Extent of Striping Modifications to provide 5' wide bike lane on both sides of US20 from 5th Street to O.B. Riley / Cook (See next page for details)

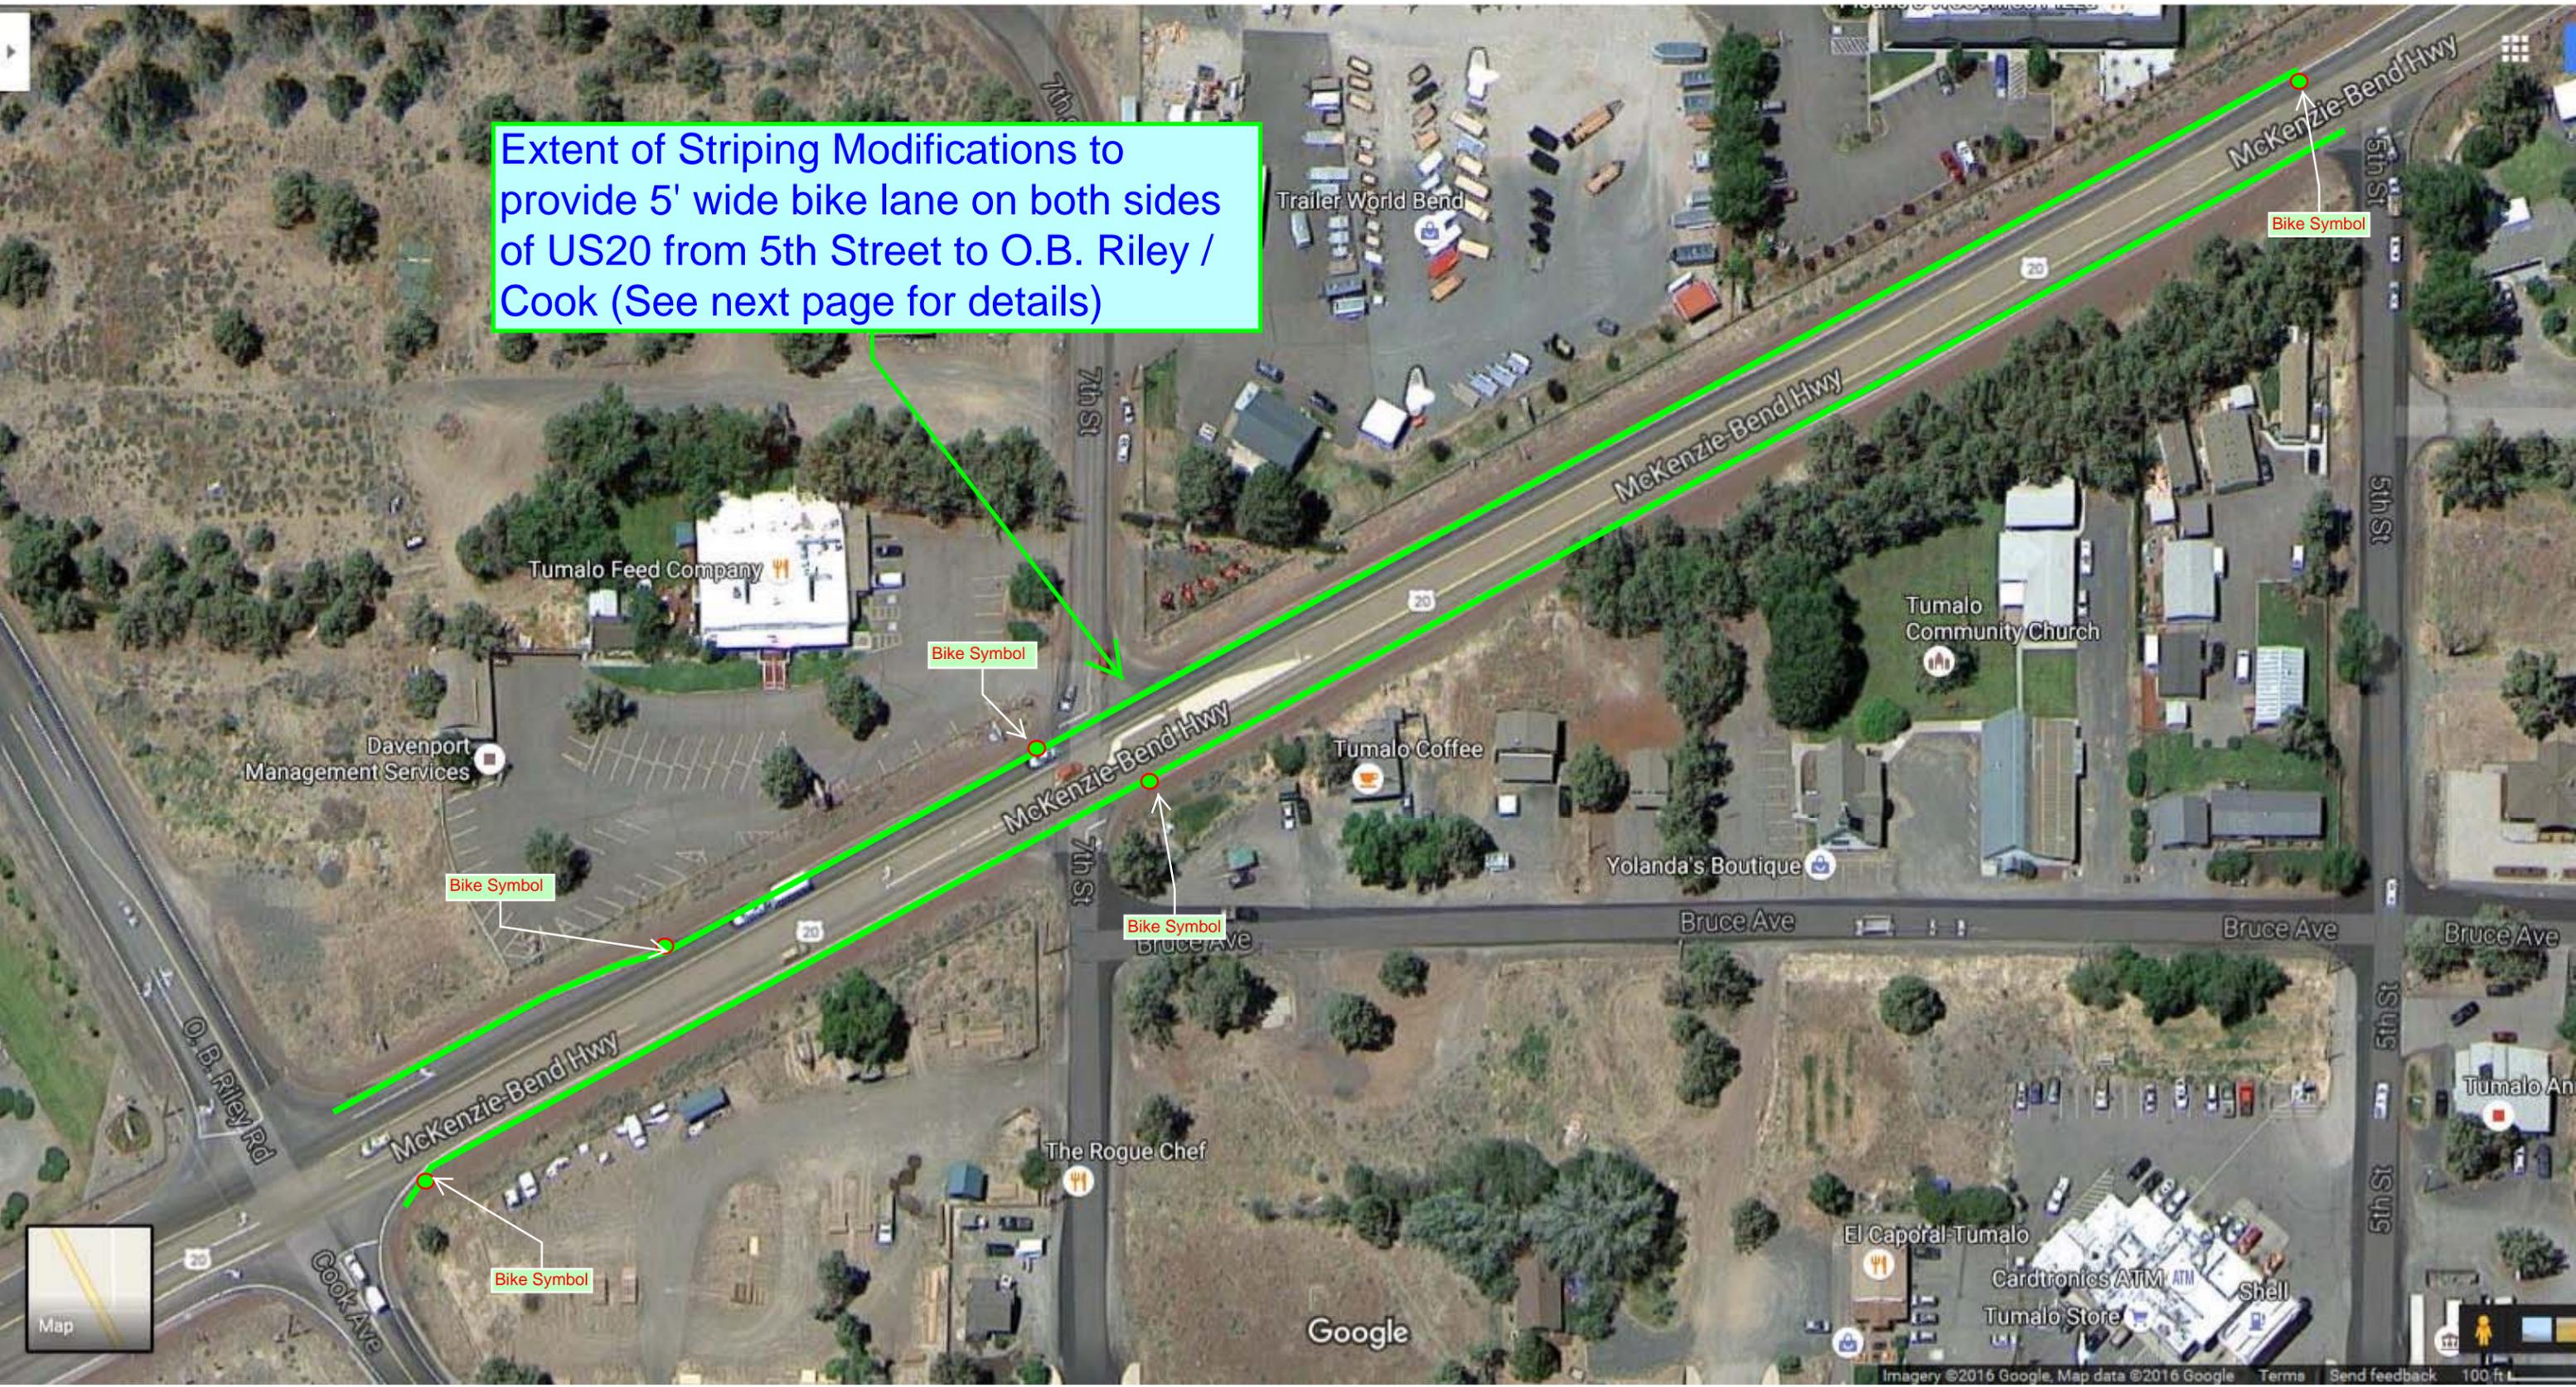
Existing 4.3' shoulder restriped for 5.3' to create 5' bike lane. As a result, red cinder treatment does not get replaced because it is not allowed for bike lane, instead bike symbols and 8" thick line (currently 4" thick)

Existing median width of 15.4' gets changed to 13.4'

Existing 4.3' shoulder restriped for 5.3' to create 5' bike lane. As a result, red cinder treatment does not get replaced because it is not allowed for bike lane, instead bike symbols and 8" thick line (currently 4" thick)

Existing 3' shy distance from median island becomes a 2' shy

12' travel lane shifted 1'

Keep existing 12' travel lane

Keep existing 12' travel lane

Existing median width of 19.4' gets changed to 17.4'

Existing 3' shy distance from median island becomes a 2' shy

12' travel lane shifted 1'

12' travel lane shifted 1'
